# Technical Service Information

## FORD 5R55W/S

### TICKING OR RATTLING NOISE FROM BELLHOUSING

Figure 1

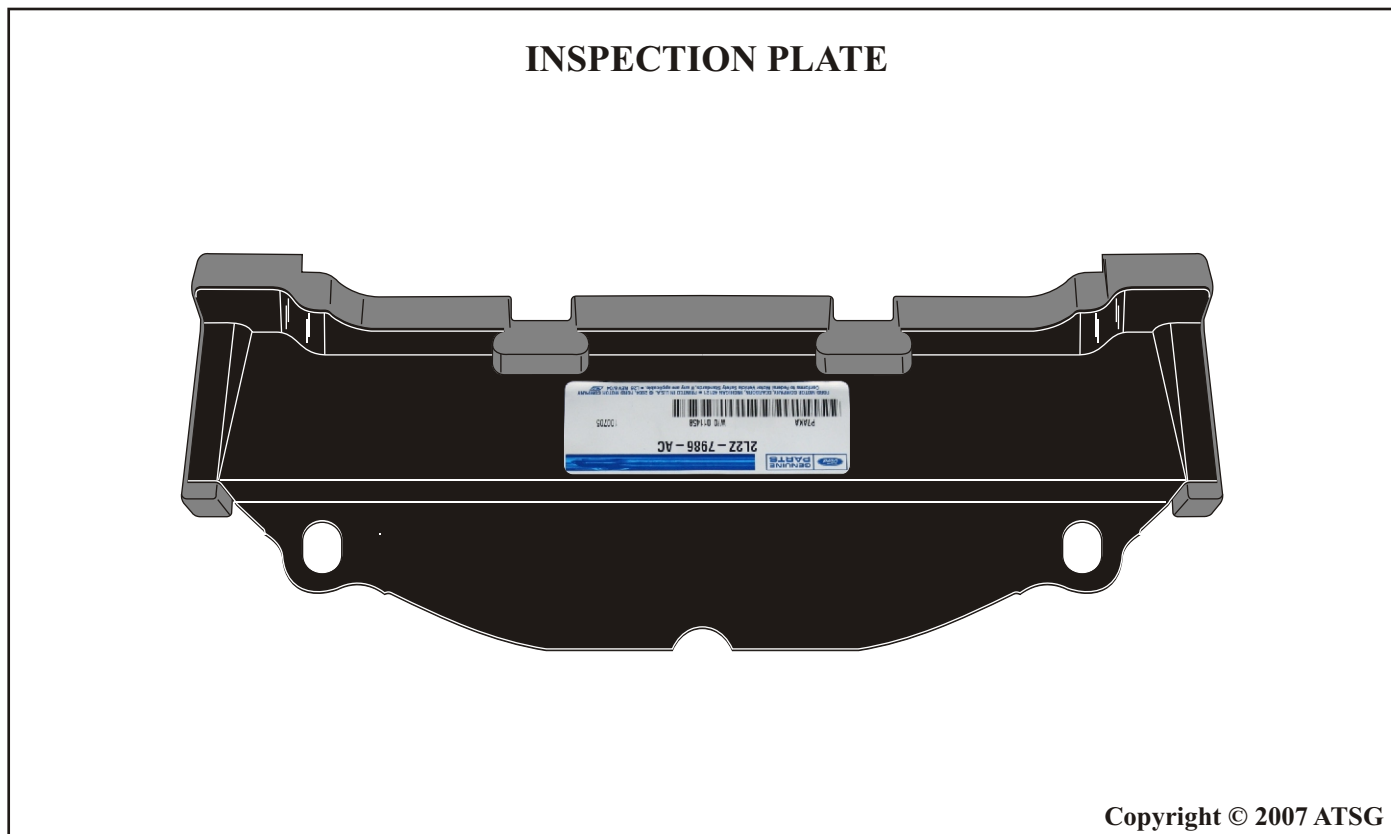
**COMPLAINT:** Explorer and Mountaineer models equipped with the 5R55W/S transmissions may exhibit a ticking or rattling noise coming from the bellhousing of the transmission. This noise can be commonly mistaken as a cracked flywheel or a mis-alignment of the flex-plate to the torque converter.

**CAUSE:** The cause may be, the plate between the engine block and the bellhousing is flexing, with increased engine rpm, causing the noise.

**CORRECTION:** Ford Motor Company has released a new style inspection plate, which is located at the bottom of the bellhousing, that has foam rubber to insulate the plate between the engine and transmission to keep it from flexing. Replace the inspection plate with new design as shown in Figure 1.

INSPECTION PLATE.....2L2Z-7986-AC
